REV	APV	THIS PRINT IS THE PROPERTY OF ADC. IT SHALL NOT BE COPIED WITHOUT PERMISSION.		TITLE SCHEMATIC, DUAL STAGE AMPL. ASSY CLASS AB, LOW BAND (1265-1413)			
	DATE						
	ECO						
	REV						
MATERIAL		DWN	GK	12/27/95	DWG. NO.		REV
FINISH		CHK	JAG	3/21/96	1265-3413		AO
		REL	JAG	3/21/96	C	SCALE 1=1	SHEET 1 OF 1

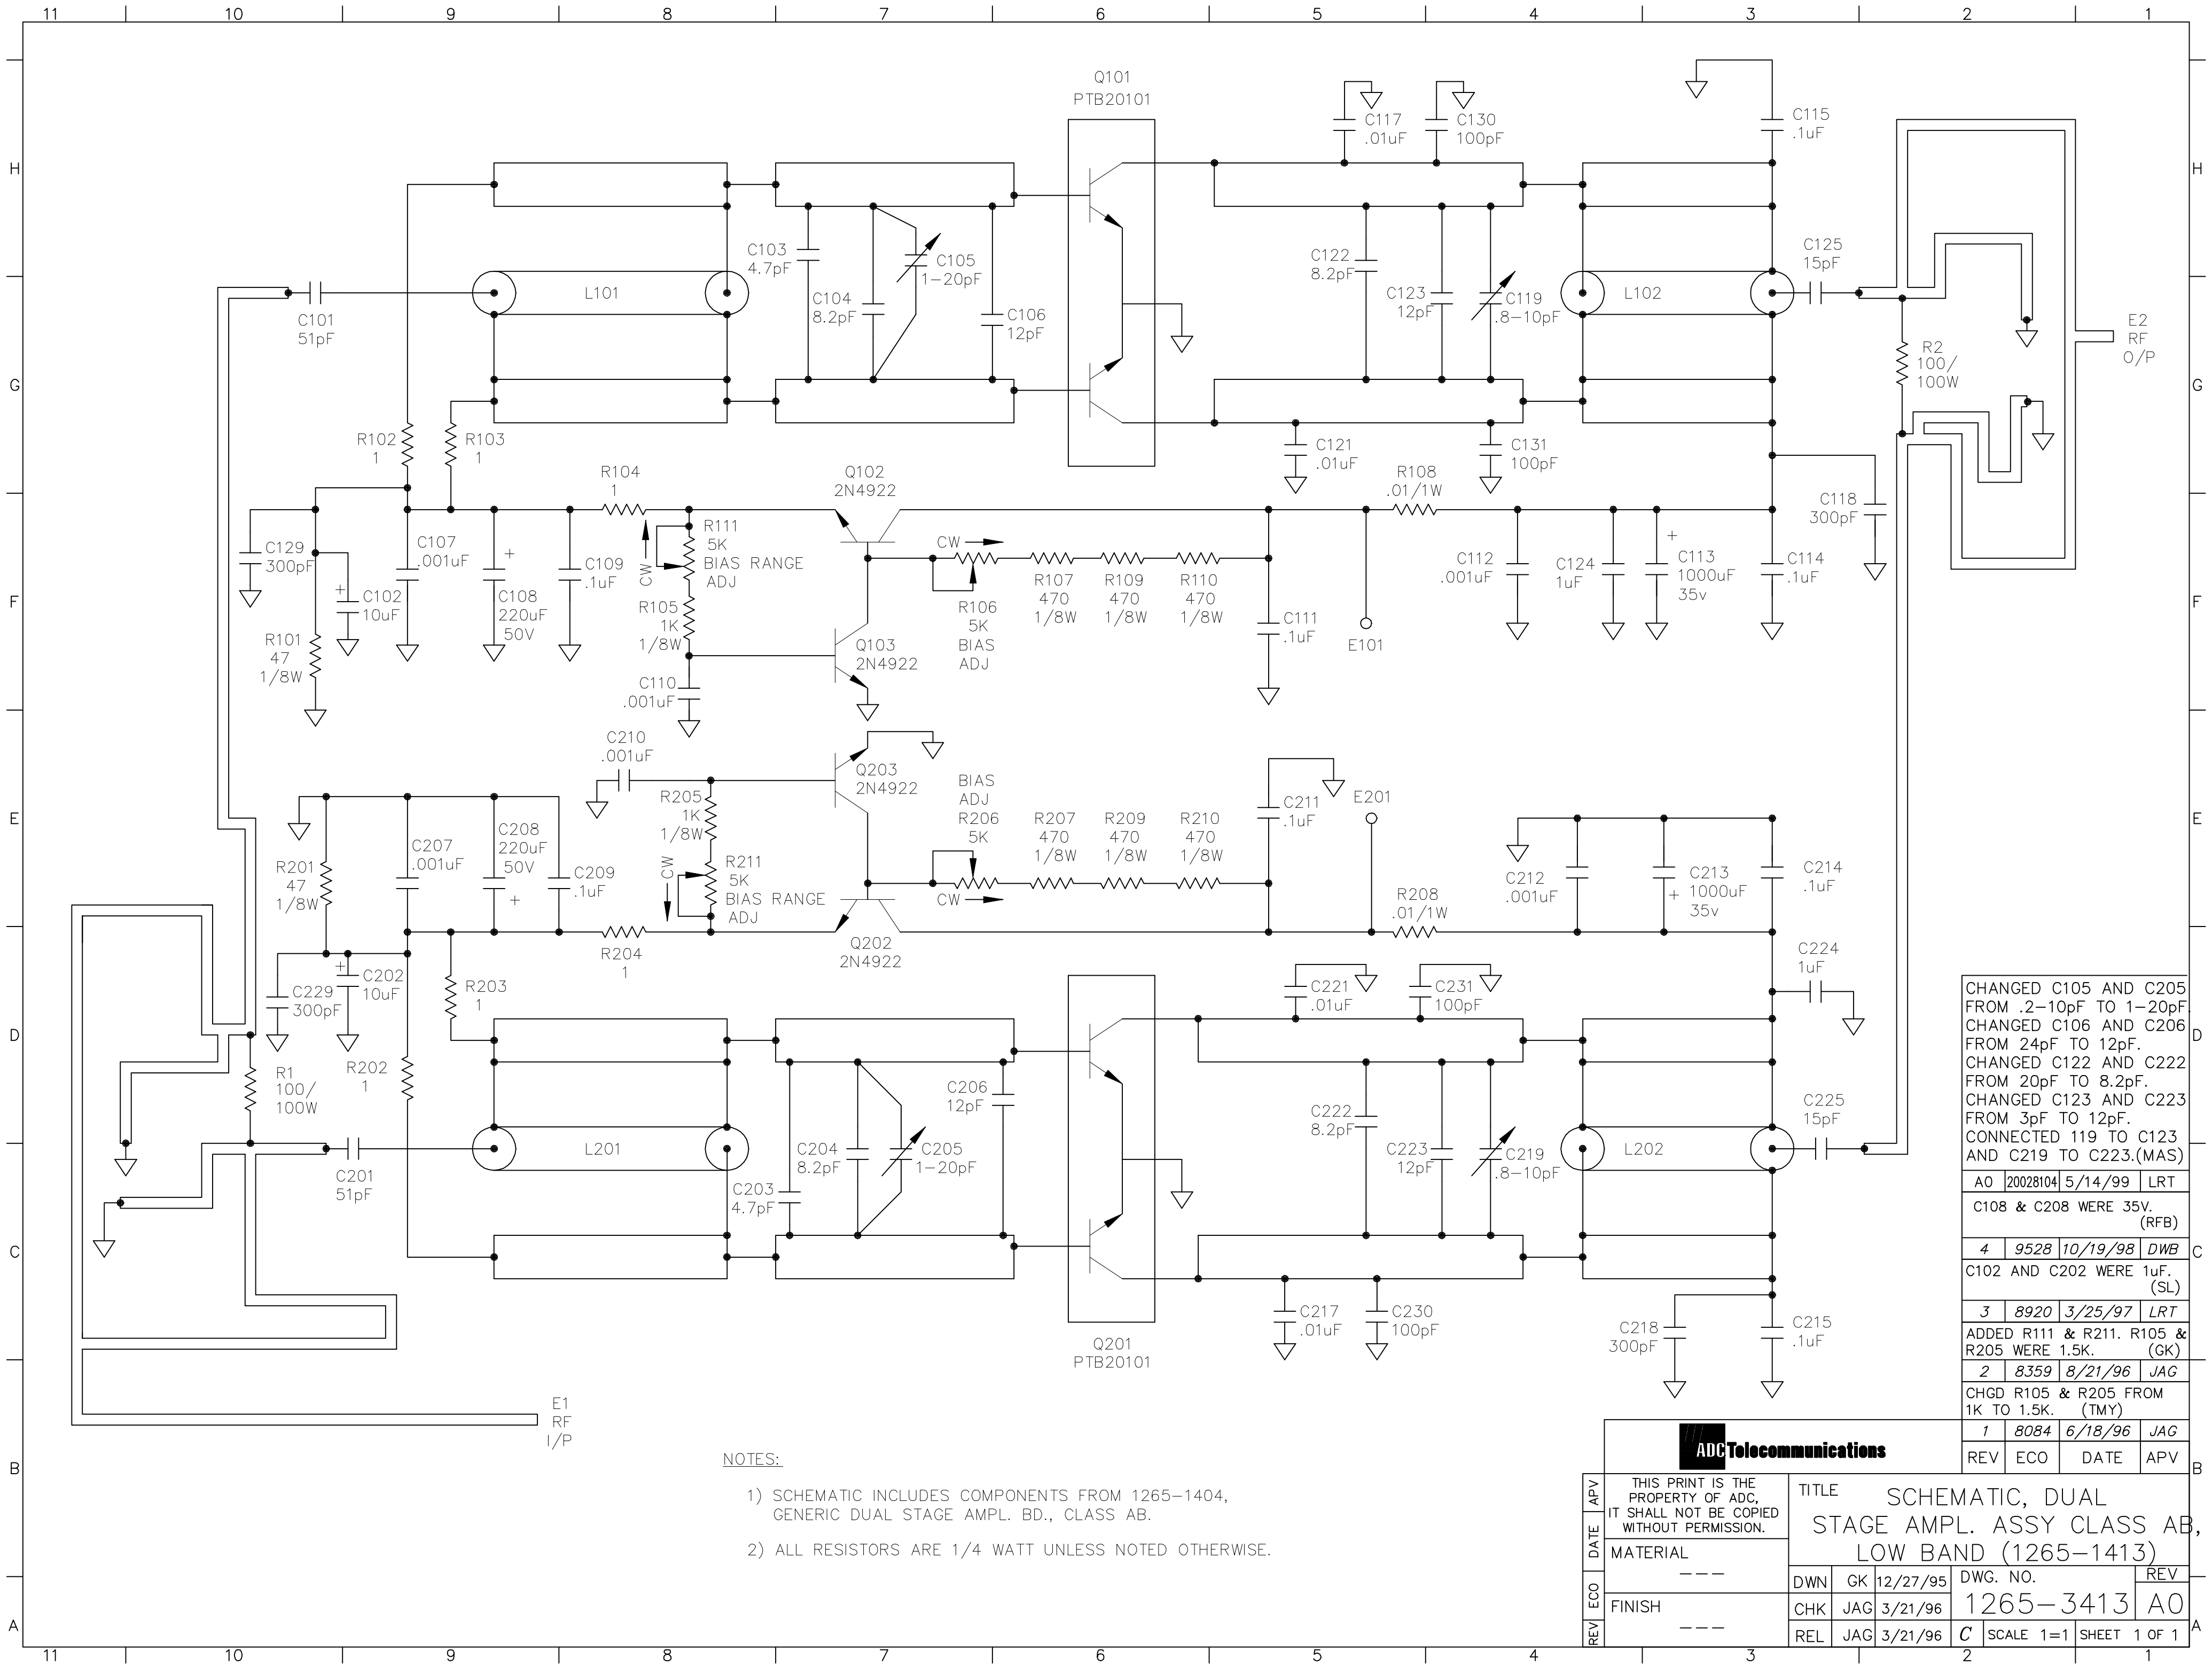
CHANGED C105 AND C205 FROM .2-10pF TO 1-20pF
CHANGED C106 AND C206 FROM 24pF TO 12pF.
CHANGED C122 AND C222 FROM 20pF TO 8.2pF.
CHANGED C123 AND C223 FROM 3pF TO 12pF.
CONNECTED 119 TO C123 AND C219 TO C223.(MAS)

AO	20028104	5/14/99	LRT
C108 & C208 WERE 35V. (RFB)			
4	9528	10/19/98	DWB
C102 AND C202 WERE 1uF. (SL)			
3	8920	3/25/97	LRT
ADDED R111 & R211. R105 & R205 WERE 1.5K. (GK)			
2	8359	8/21/96	JAG
CHGD R105 & R205 FROM 1K TO 1.5K. (TMY)
